ADDENDUM 04

Project: Vivion Rd Trail Segment 1
PROJECT NO: TAP 3454(401)

This addendum forms a part of the contract documents and modifies the original procurement documents dated October 2024.

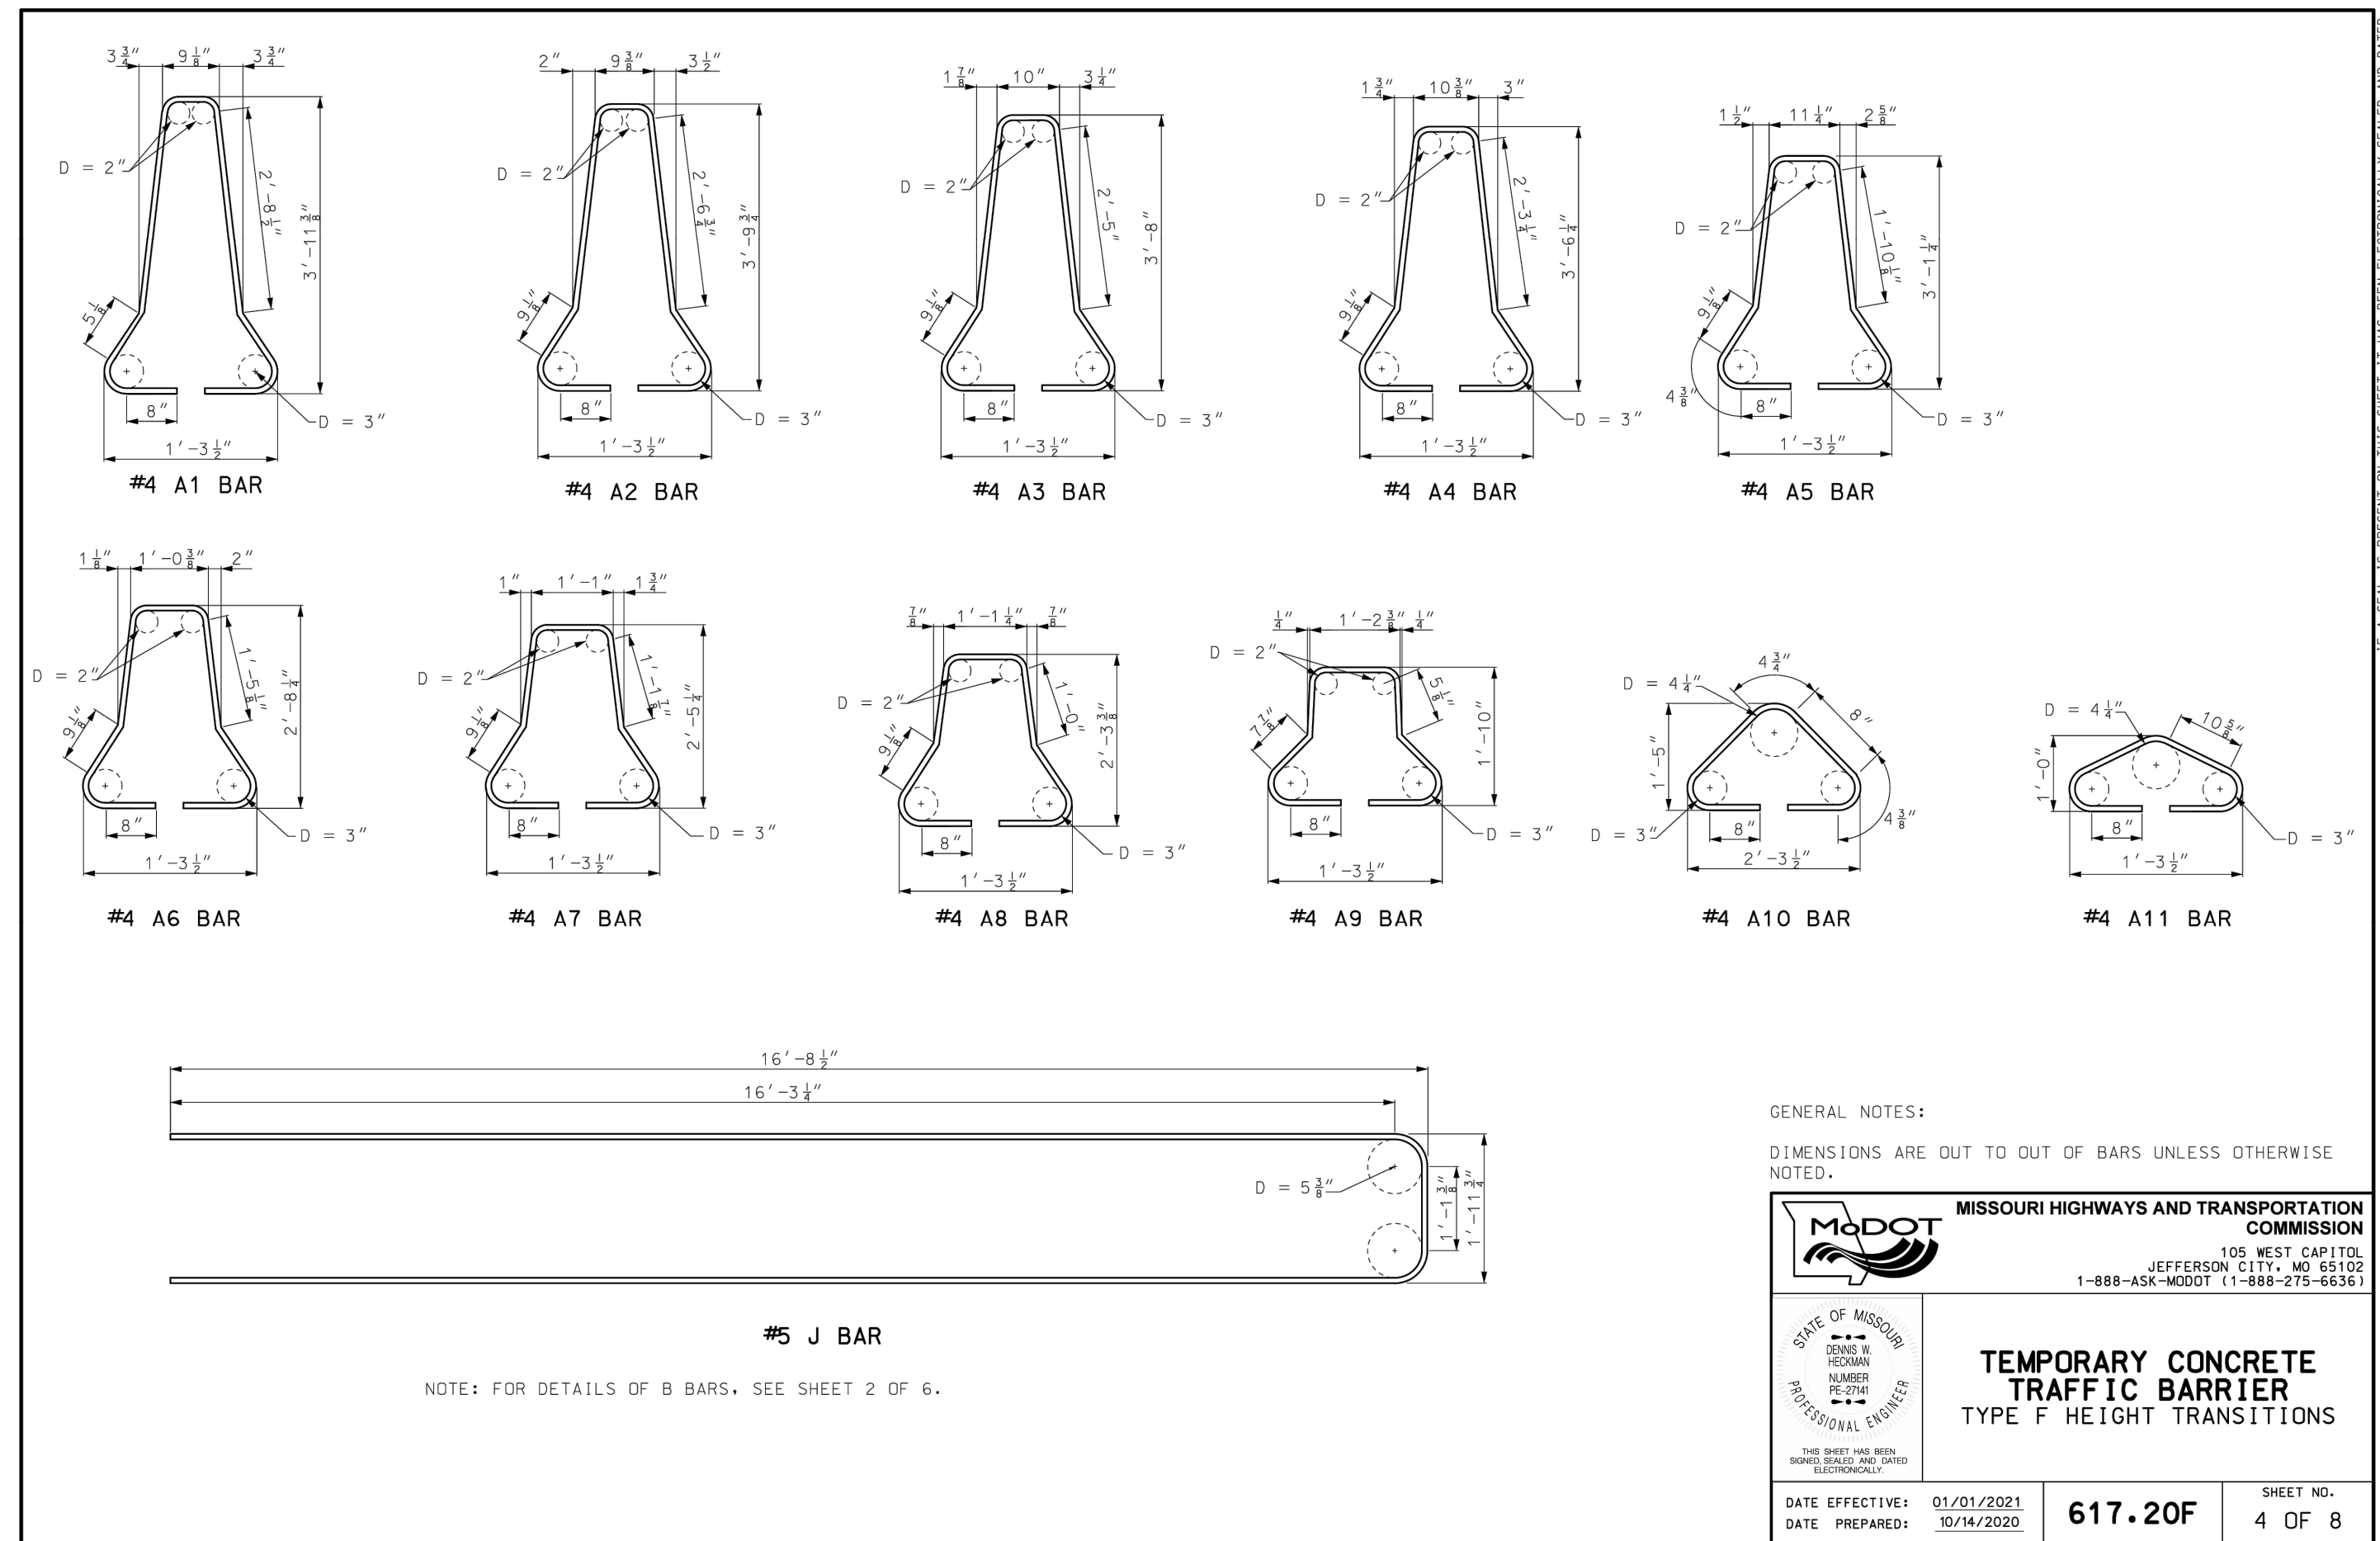
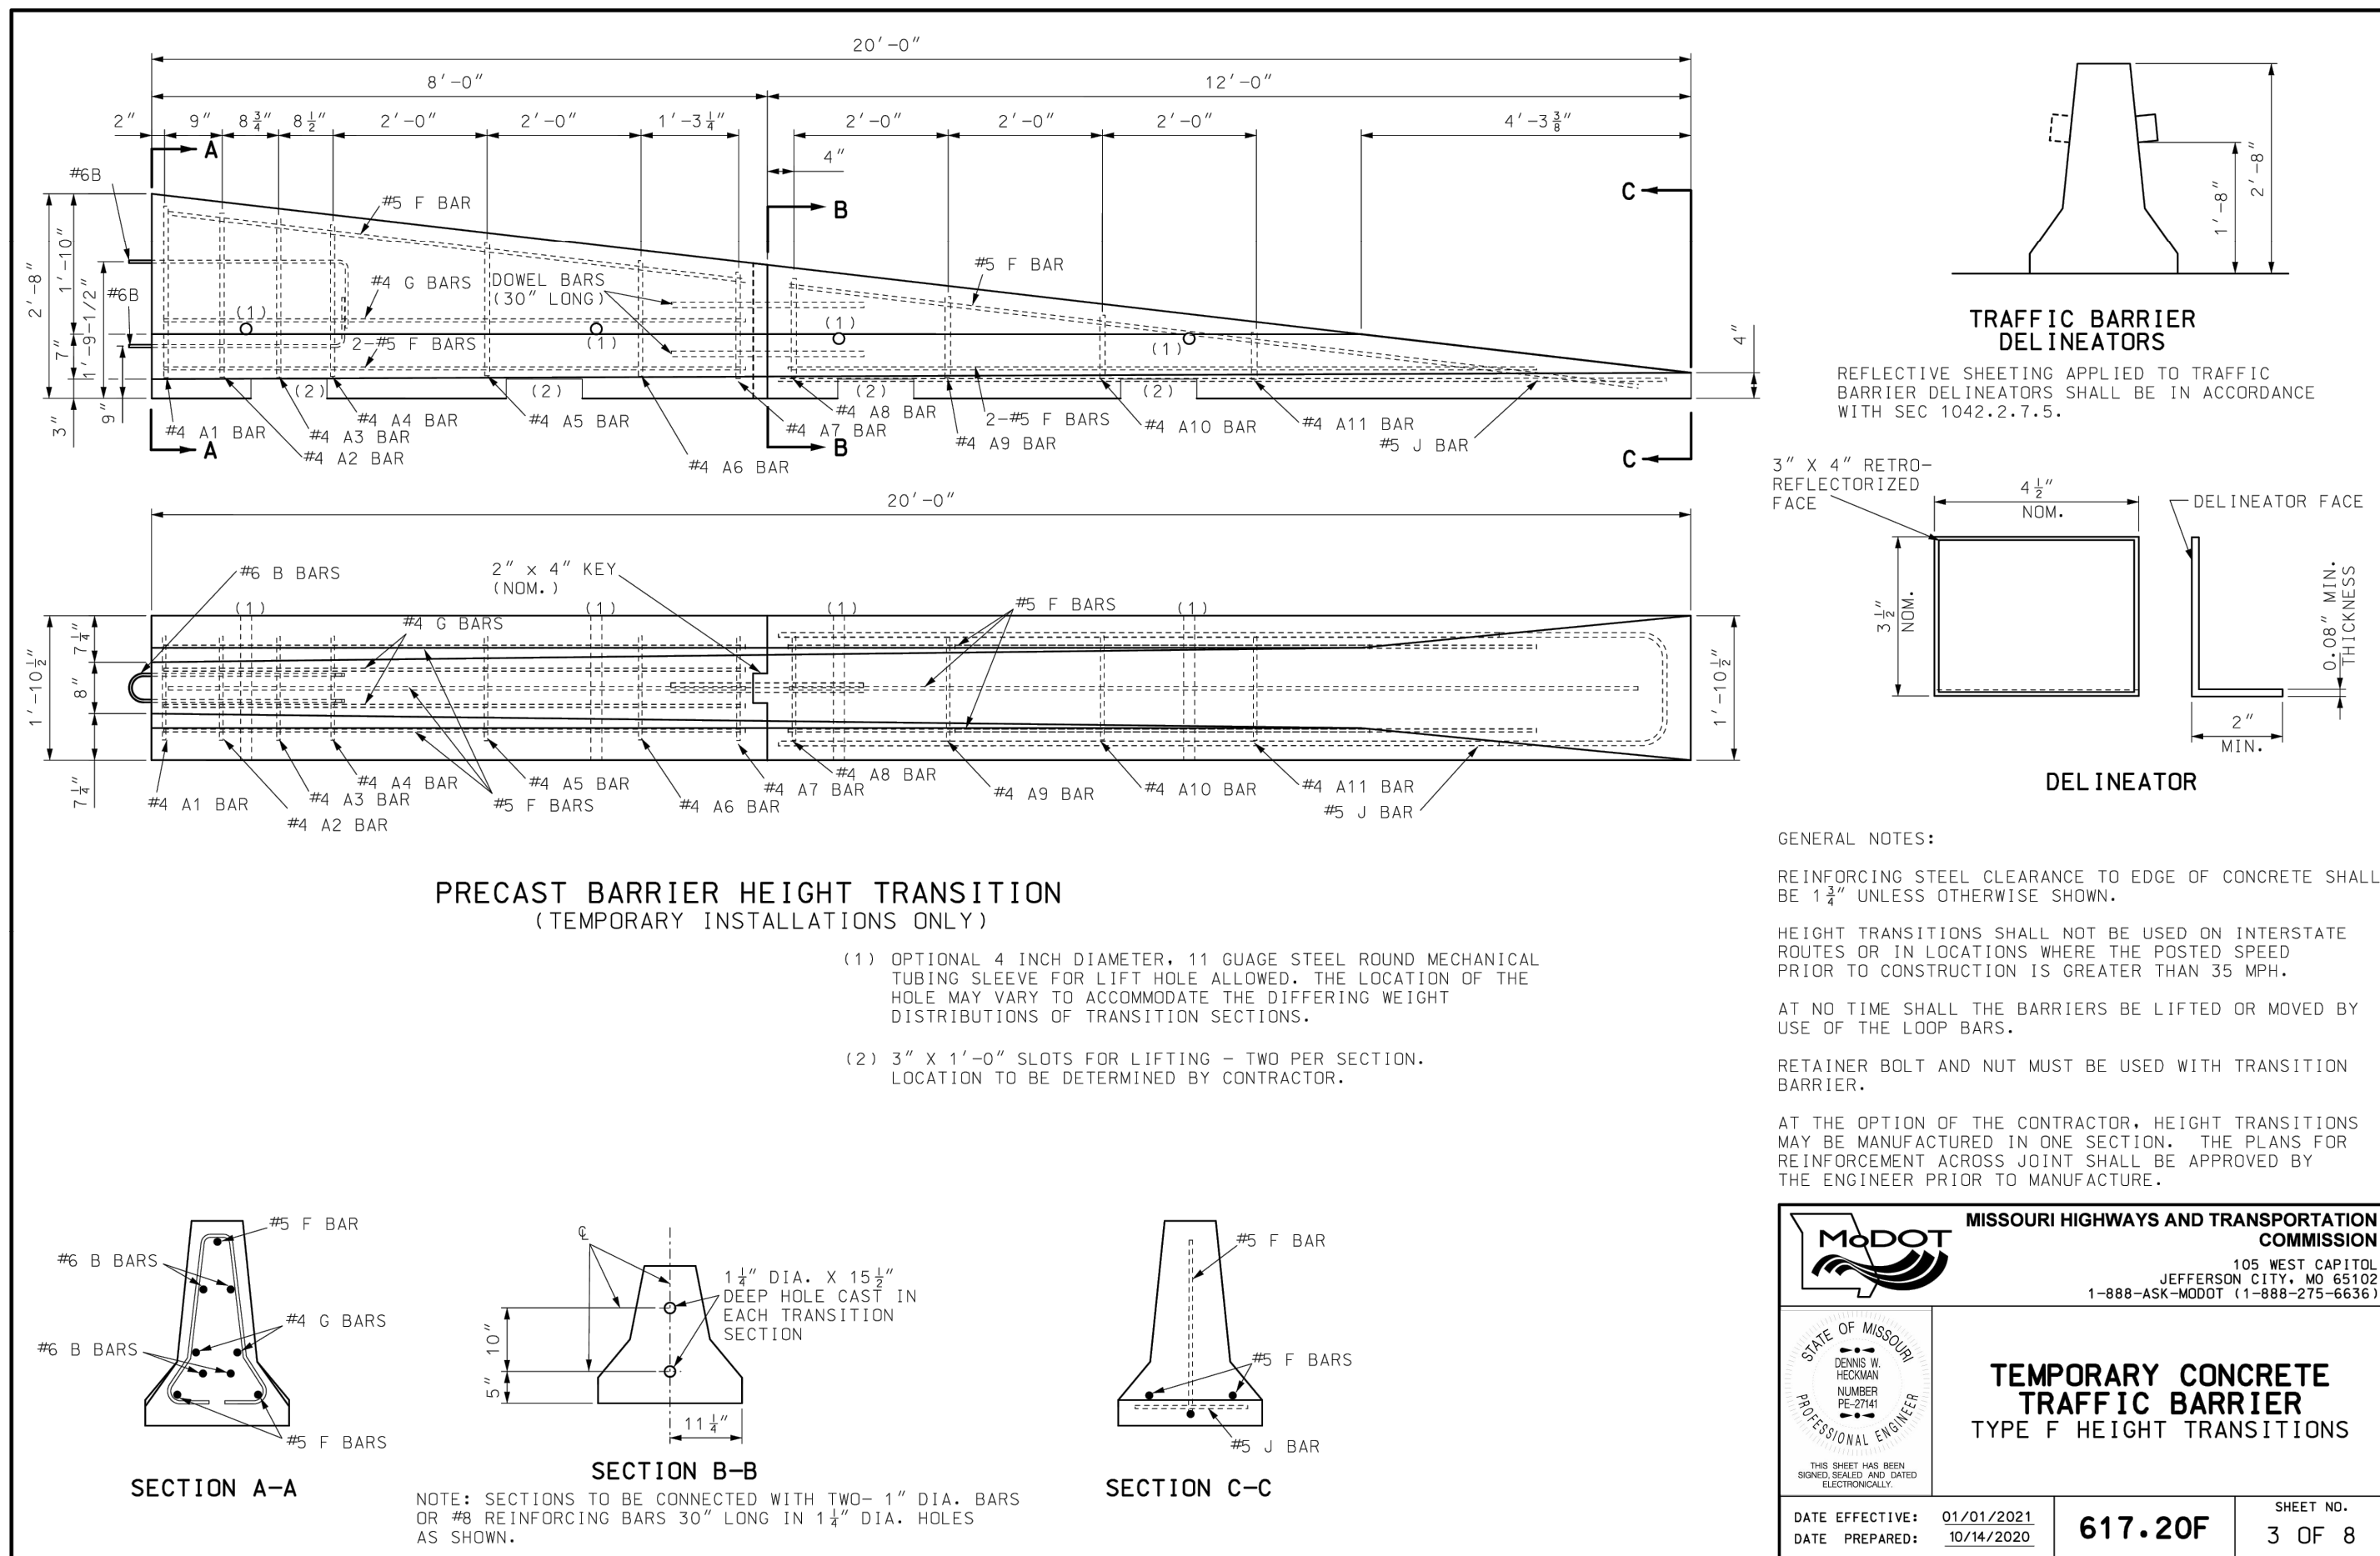
- 3. Will there be revisions coming, specifically there is a lot of confusion about Traffic Control?**

A Type F Barrier with a Tie-Down Strap is now called for in front of the guardrail and shown on sheet 26 of the plans. Appropriate details have also been added. Per discussions with MoDOT, the updates for the Type F Barriers with a Tie-Down Strap also include minimums for lane width adjacent to the barriers on the Temporary Traffic Control Plan (sheet 30 of the plans) to keep the lanes open.
